Contract No. T201504401.01
Federal Aid Project No. ESTP-N011(31)
Elkton Road, MD Line to Casho Mill Road
New Castle County

Enclosed is Addendum No. 2 for the referenced contract consisting of the following:

1. The Bid Proposal Cover, revised, to be substituted for the same page of the Proposal.
2. The following plan sheets have been revised: 3, 7, 8, 9, 10, 11, 12, 13, 14, 15, 16, 17, 18, and 141.

TS-01

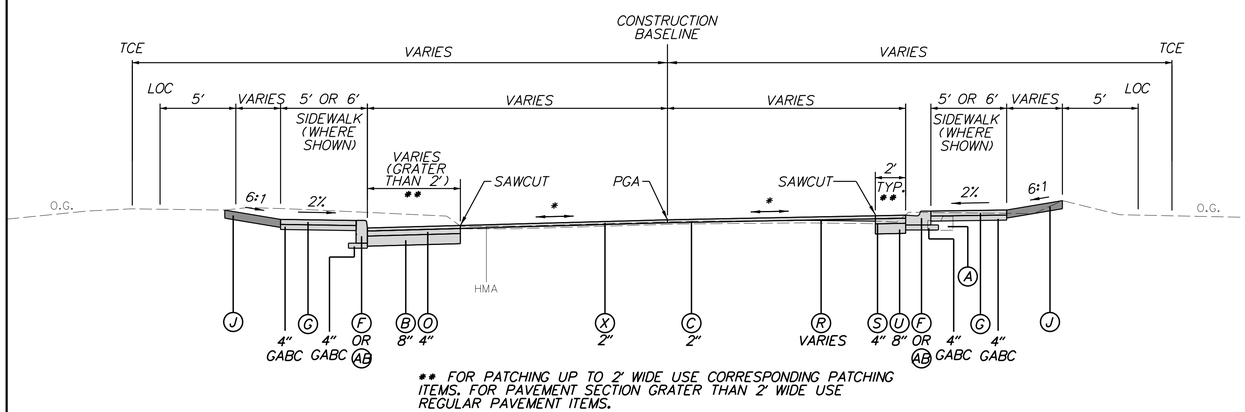
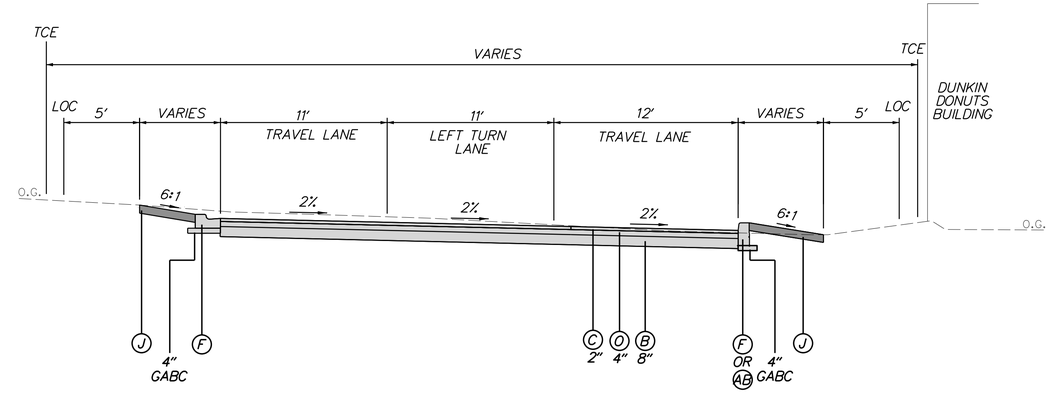
NOTES:
~~1. CONCRETE PAVEMENT ON ELKTON ROAD SHALL BE 12-1/4" TO ACCOUNT FOR GRINDING~~
2. * SLOPE VARIES, SEE GG SHEETS FOR ADDITIONAL INFO
3. FULL DEPTH PAVEMENT IN STATE OF MARYLAND CONSISTS OF 2"-12.5MM PG 64S-22, LEVEL 2, 8"-19.0MM PG 64-S-22, LEVEL 2 (2 - 4" LIFTS) AND 6" GRADED AGGREGATE BASE
4. MULTI-USE PATH PAVEMENT IN STATE OF MARYLAND CONSISTS OF 2"-12.5MM PG 64S-22, LEVEL 2 AND 6" GRADED AGGREGATE BASE

1	REPLACED PAGES 1 THRU 432	11-15-2019 (LB)
2	REMOVED NOTE #1	12-09-2019 (LB)

TS-02

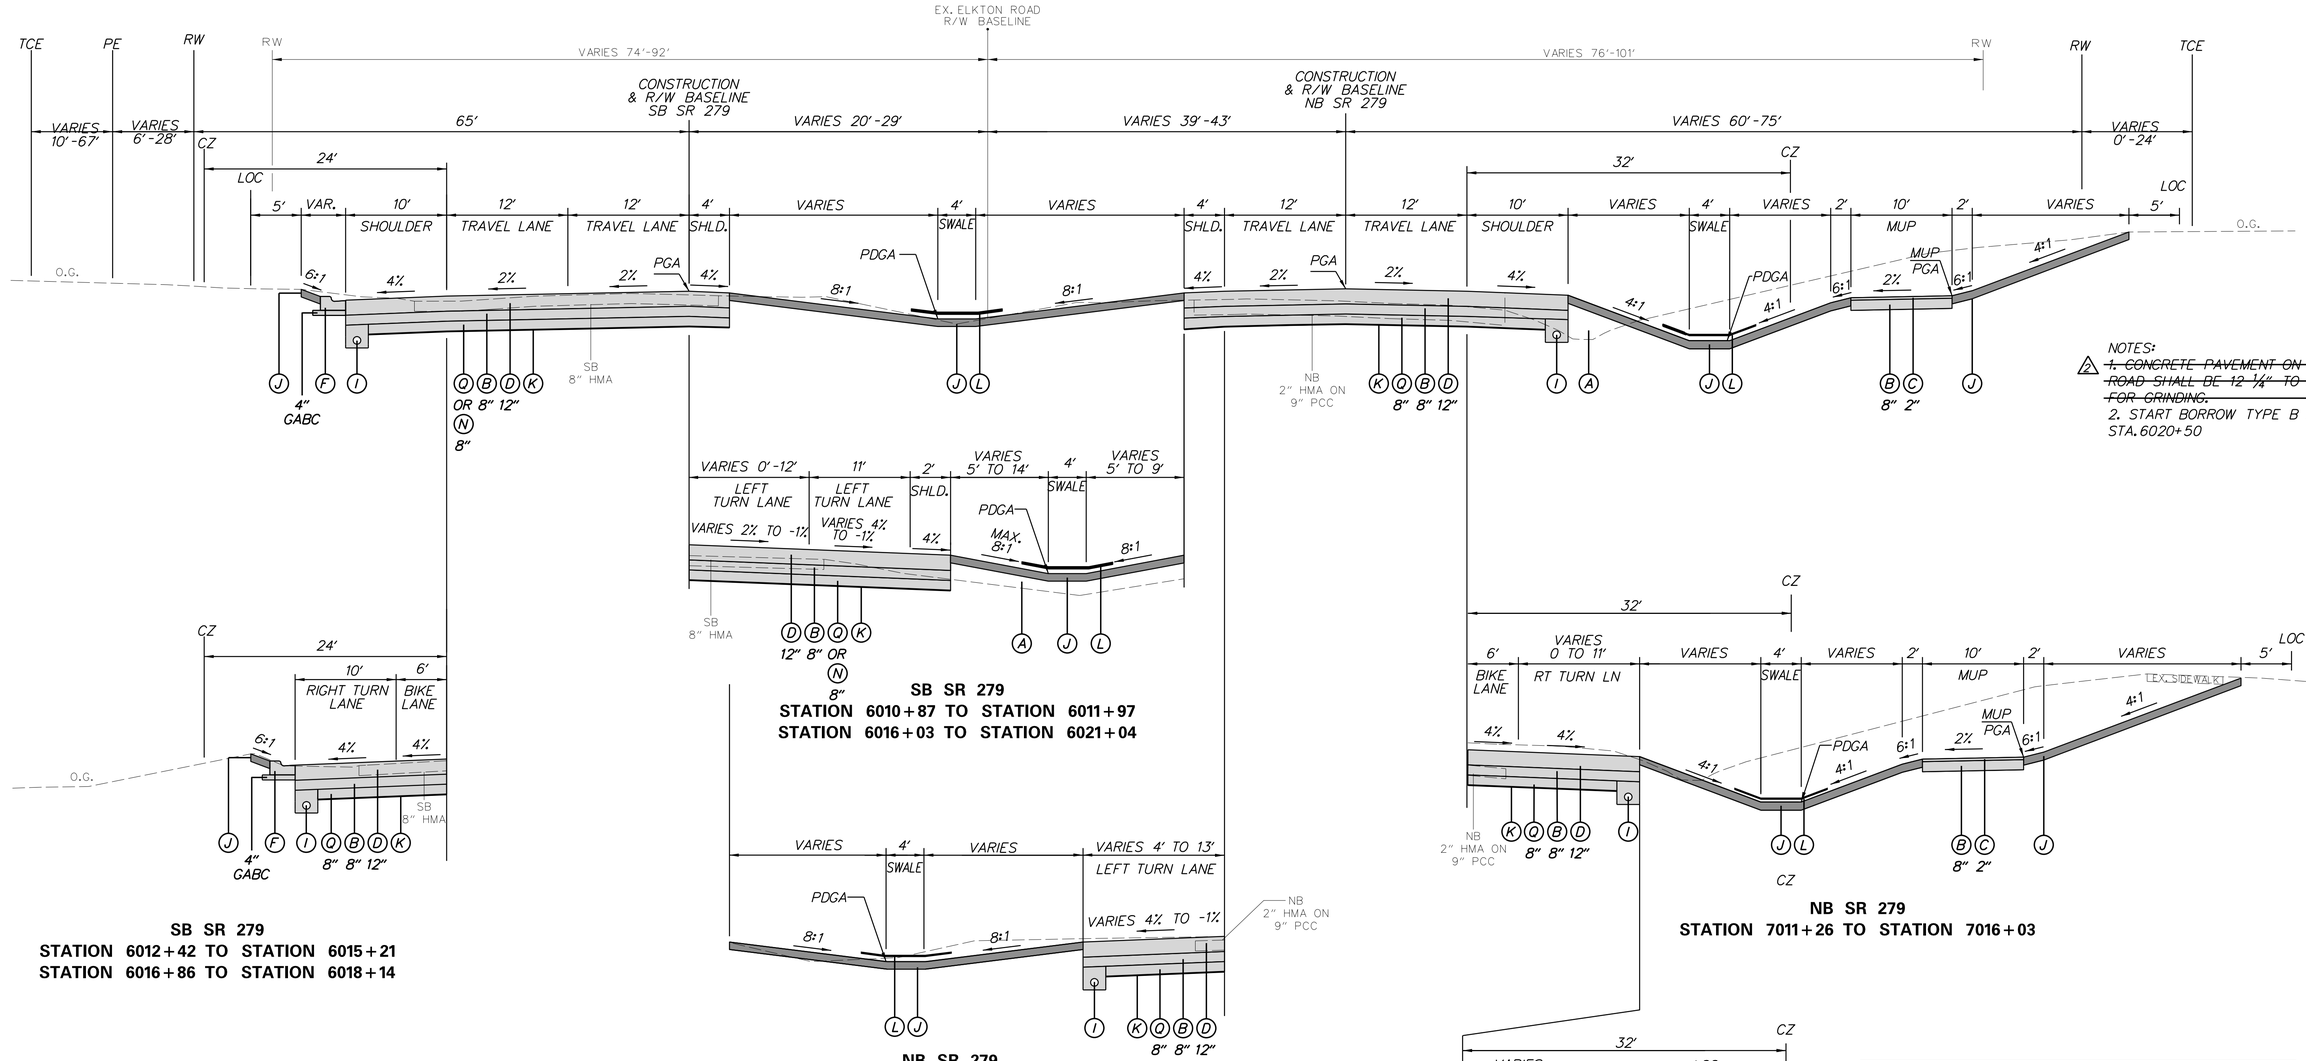
1. ~~CONCRETE PAVEMENT ON ELKTON ROAD SHALL BE 12 1/4" TO ACCOUNT FOR GRINDING.~~
2. START BORROW TYPE B AT STA. 6020+50

1	REPLACED PAGES 1 THRU 432	11-15-2019 (LB)
2	REMOVED NOTE #1	12-09-2019 (LB)

TS-04

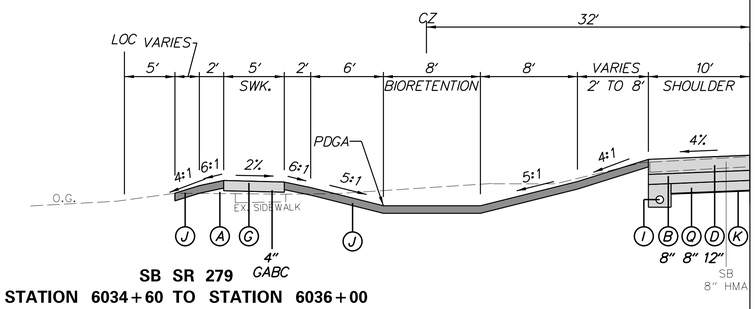
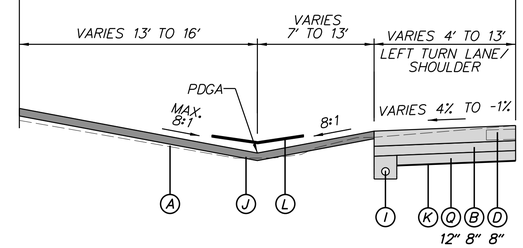
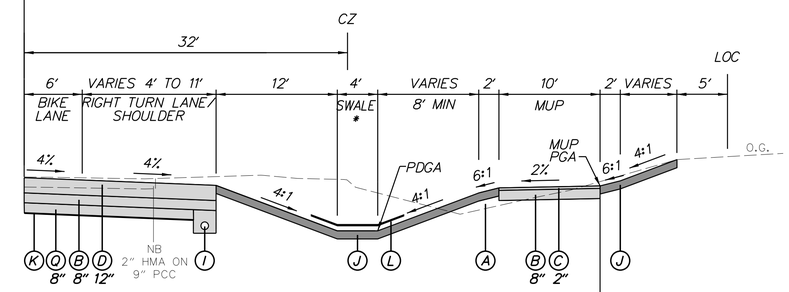
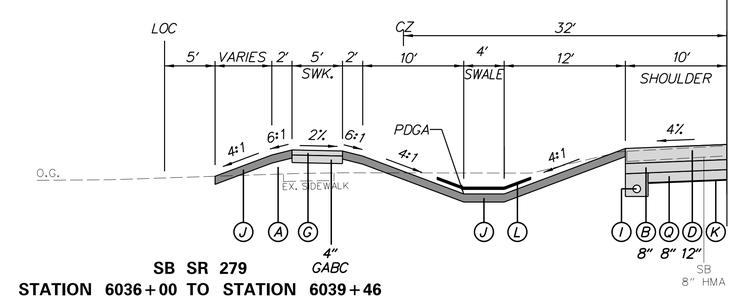
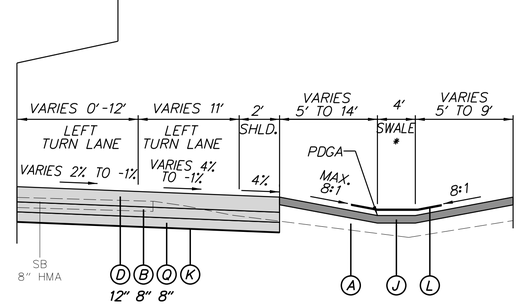
NOTES:
1. ~~CONCRETE PAVEMENT ON ELKTON ROAD NB SHALL BE 12-1/4" BEFORE FINAL GRINDING~~
2. USE EROSION CONTROL BLANKET MULCH FOR ENTIRE 2:1 SLOPES OR STEEPER.

ADDENDA / REVISIONS		
1	REPLACED PAGES 1 THRU 432	11-15-2019 (LB)
2	REMOVED NOTE *1	12-09-2019 (LB)

TS-05

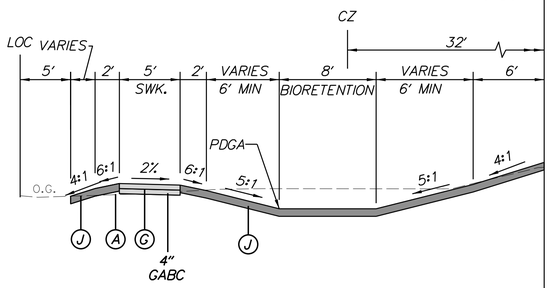
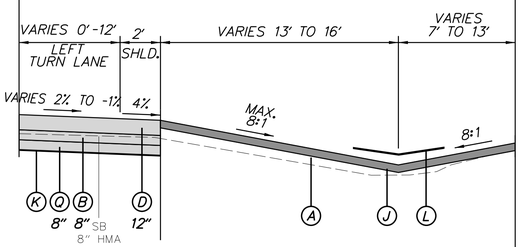
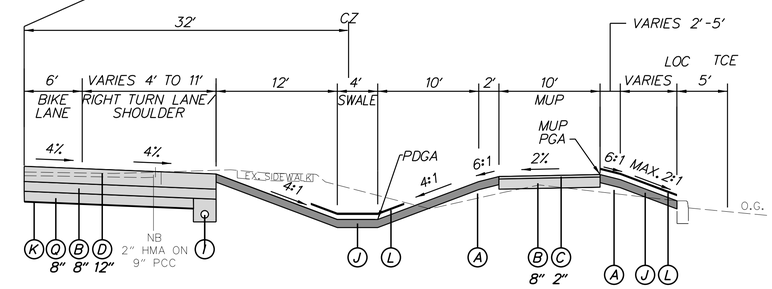
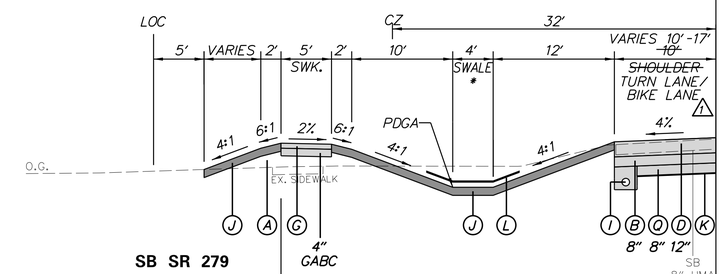
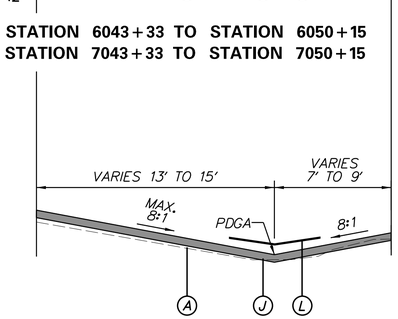
~~1. CONCRETE PAVEMENT ON ELKTON ROAD SHALL BE 12 1/4" BEFORE FINAL GRINDING~~
2. USE EROSION CONTROL BLANKET MULCH FOR ENTIRE 2:1 SLOPES OR STEEPER.

1	REPLACED PAGES 1 THRU 432	11-15-2019 (LB)
2	REMOVED NOTE #1	12-09-2019 (LB)

TS-06

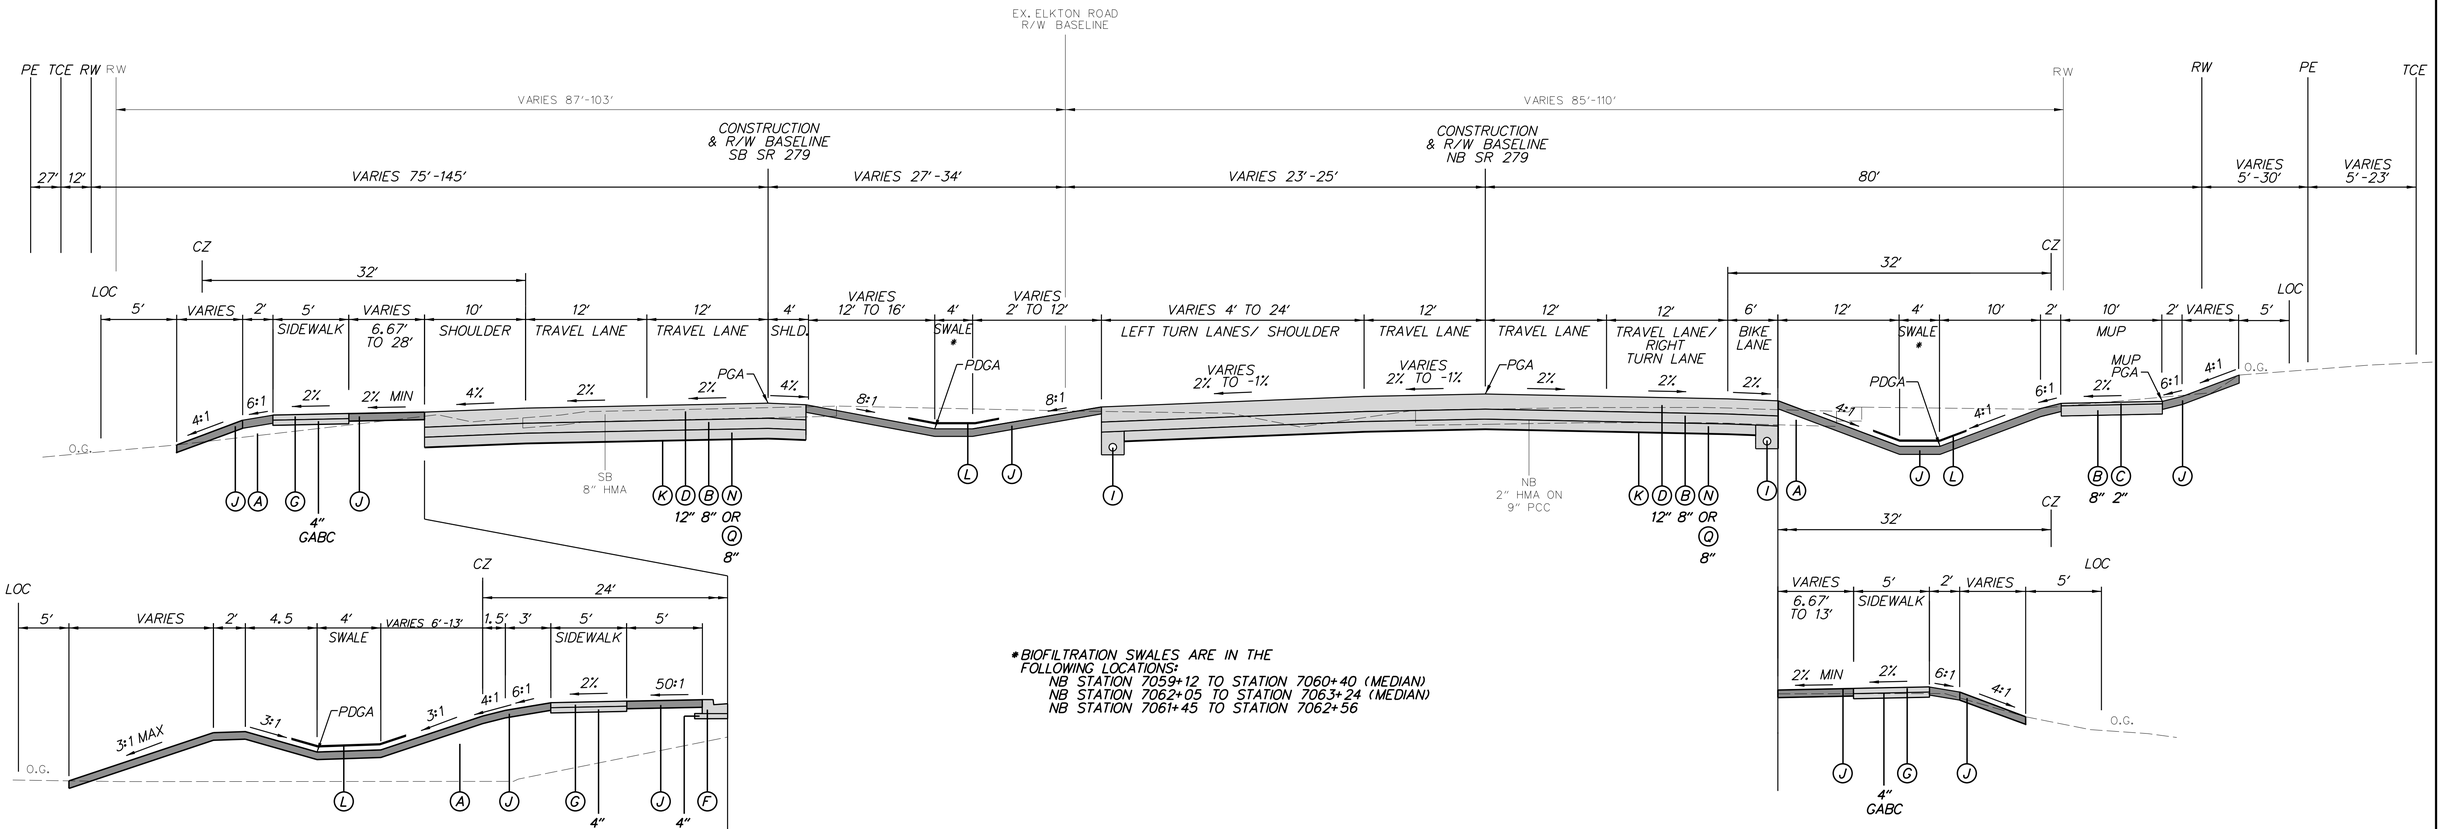
1. ~~CONCRETE PAVEMENT ON ELKTON ROAD SHALL BE 12 ¼" TO ACCOUNT FOR GRINDING~~
2. START BORROW TYPE B AT STA. 6060+50 AND STA. 7060+50

1	REPLACED PAGES 1 THRU 432	11-15-2019 (LB)
2	REMOVED NOTE #1	12-09-2019 (LB)

TS-07

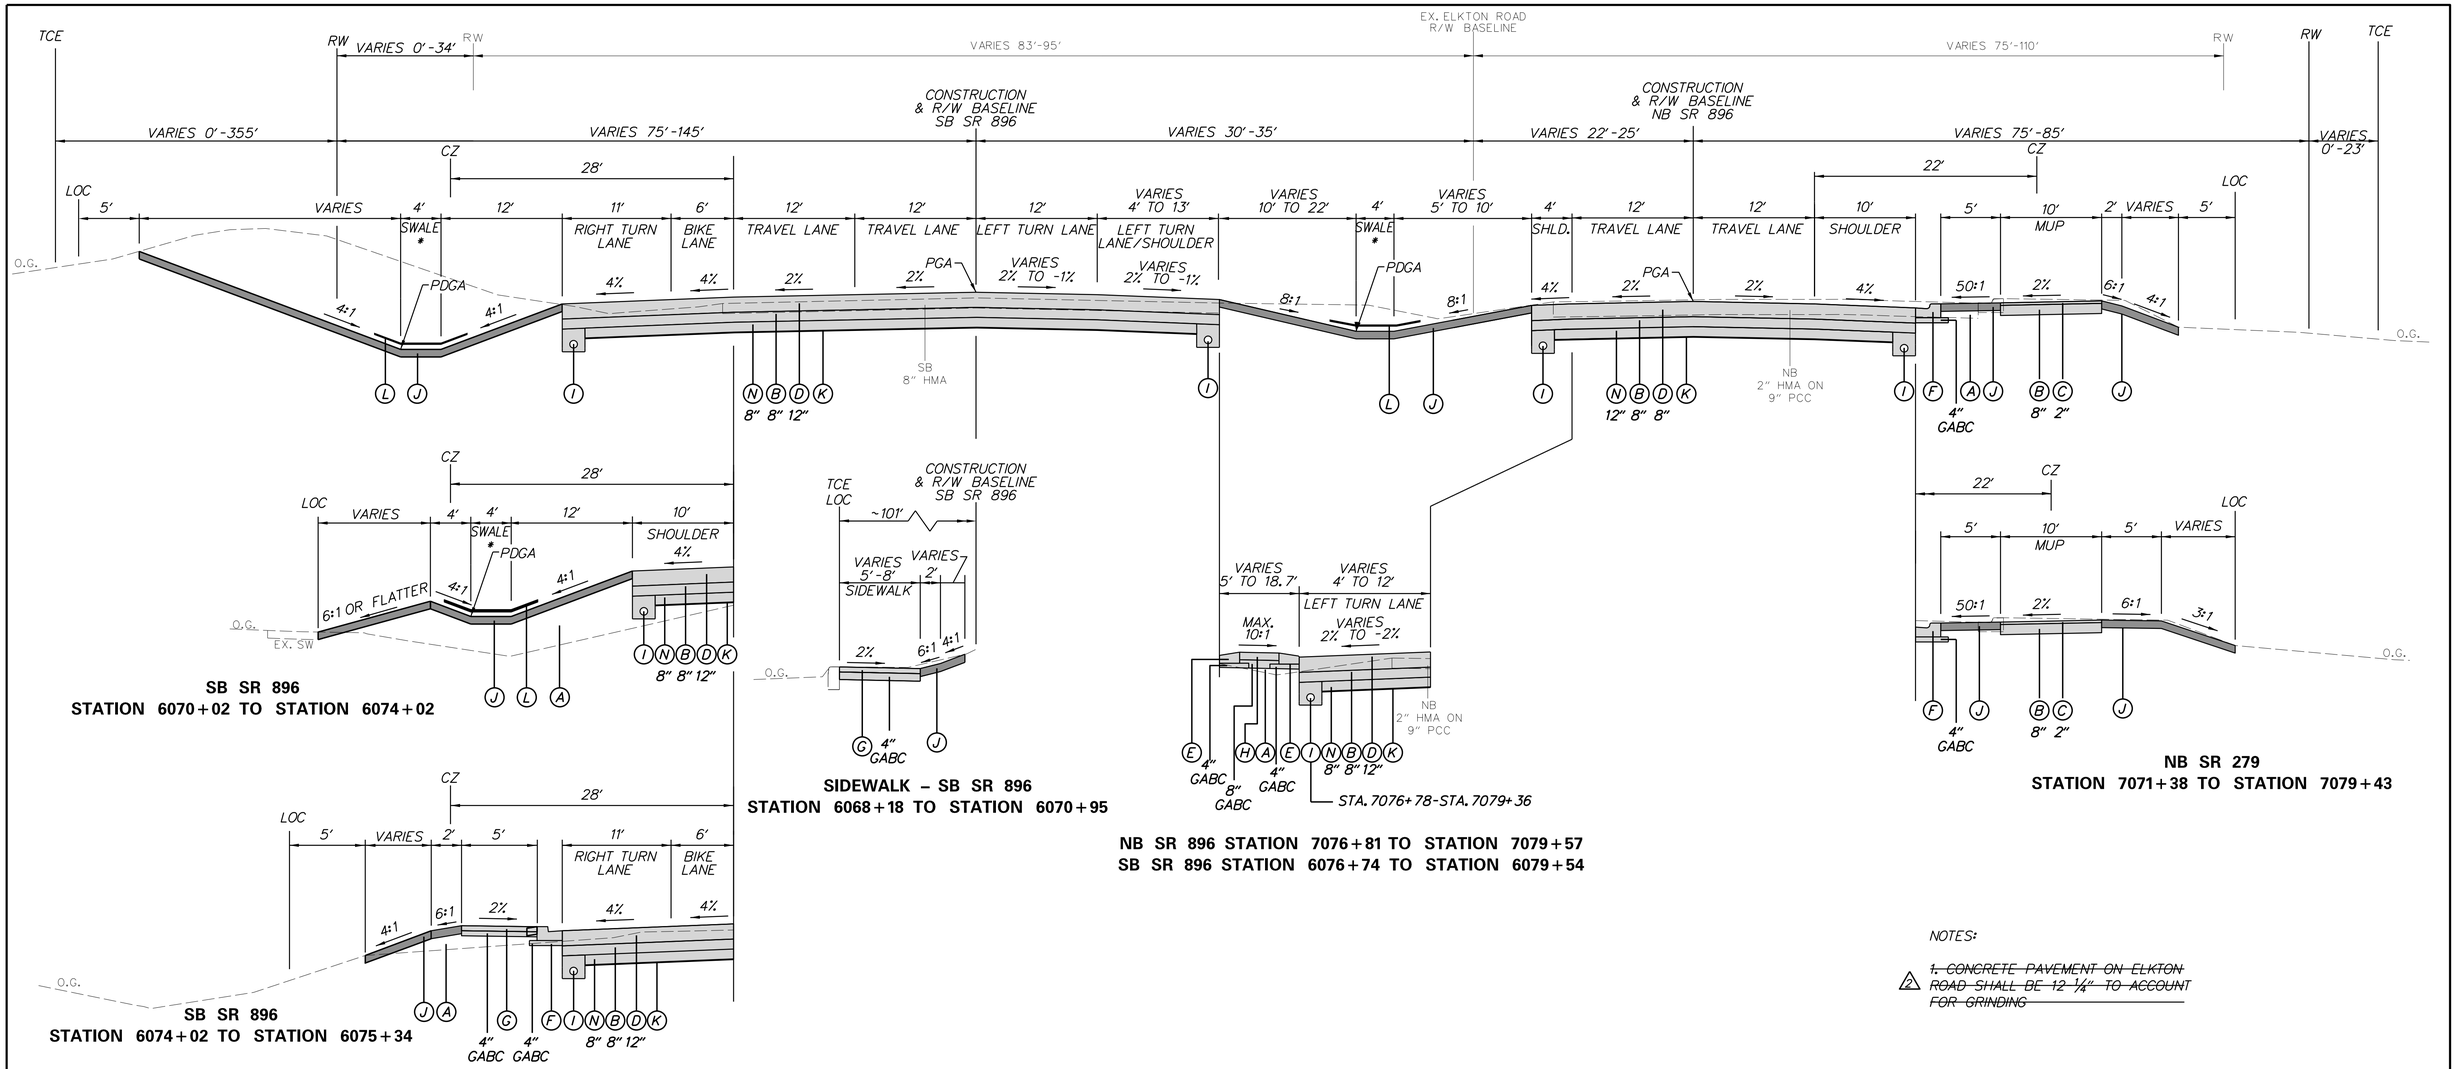
~~1. CONCRETE PAVEMENT ON ELKTON ROAD SHALL BE 12 1/4" TO ACCOUNT FOR GRINDING~~

1	REPLACED PAGES 1 THRU 432	11-15-2019 (LB)
2	REMOVED NOTE #1	12-09-2019 (LB)

TS-08

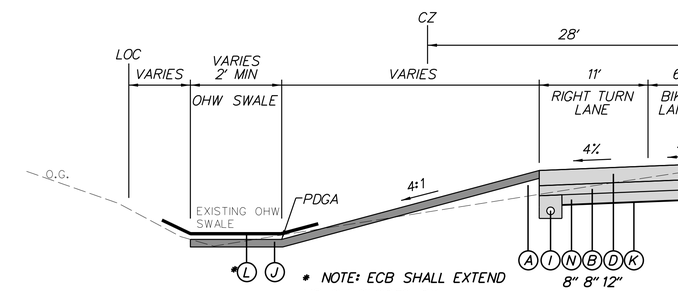
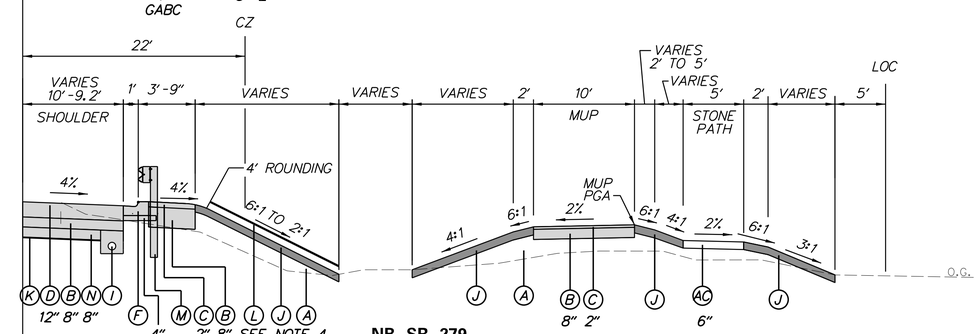
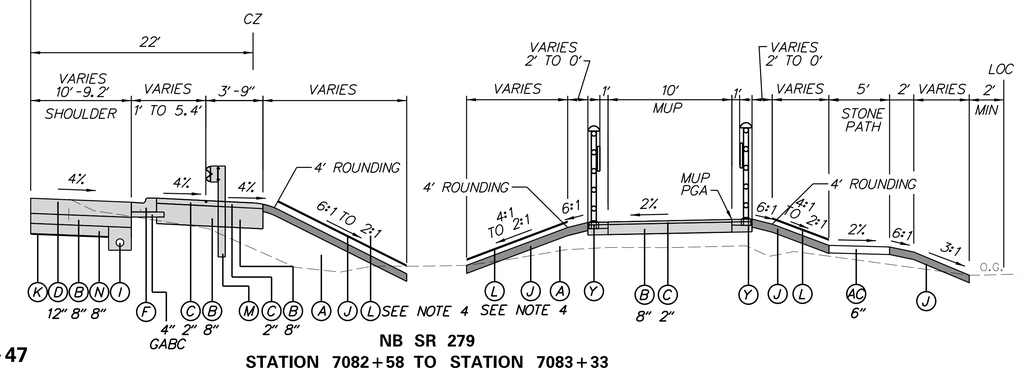
1. ~~CONCRETE PAVEMENT ON ELKTON ROAD SHALL BE 12 1/4" TO ACCOUNT FOR GRINDING~~
2. USE EROSION CONTROL BLANKET MULCH FOR ENTIRE 2:1 SLOPES OR STEEPER.

1	REPLACED PAGES 1 THRU 432	11-15-2019 (LB)
2	REMOVED NOTE #1	12-09-2019 (LB)
